V2500-A5 SERIES PROPULSION SYSTEM SERVICE BULLETIN

This document transmits Revision 1 to Service Bulletin EV2500-73-0184

V2500-ENG-73-0184

ENGINE - FUEL AND CONTROL - TO PROVIDE A NEW ELECTRONIC ENGINE CONTROL (EEC) WITH A5
SCN17/V SOFTWARE

FAMILY TREE - ELECTRONIC ENGINE CONTROL (EEC) REF. CATALOG SEQUENCE NO. 73-22-34.
FIG. 01 ITEM 280
Figure 2

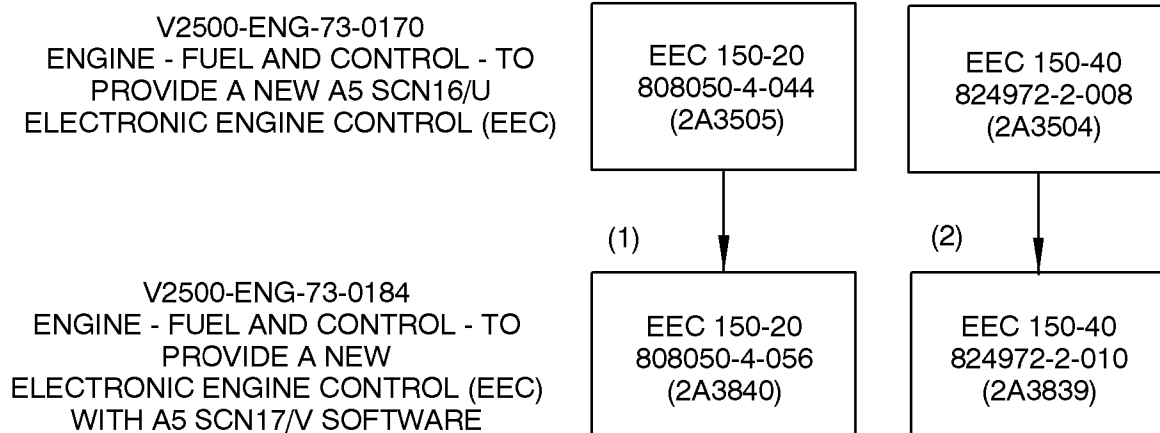
Reidentified Parts Data		
New PN	Keyword	Old PN
808050-4-056 (2A3840)	Control, Electronic Engine (150-20)	808050-4-044 (2A3505)
824972-2-010 (2A3839)	Control, Electronic Engine (150-40)	824972-2-008 (2A3504)
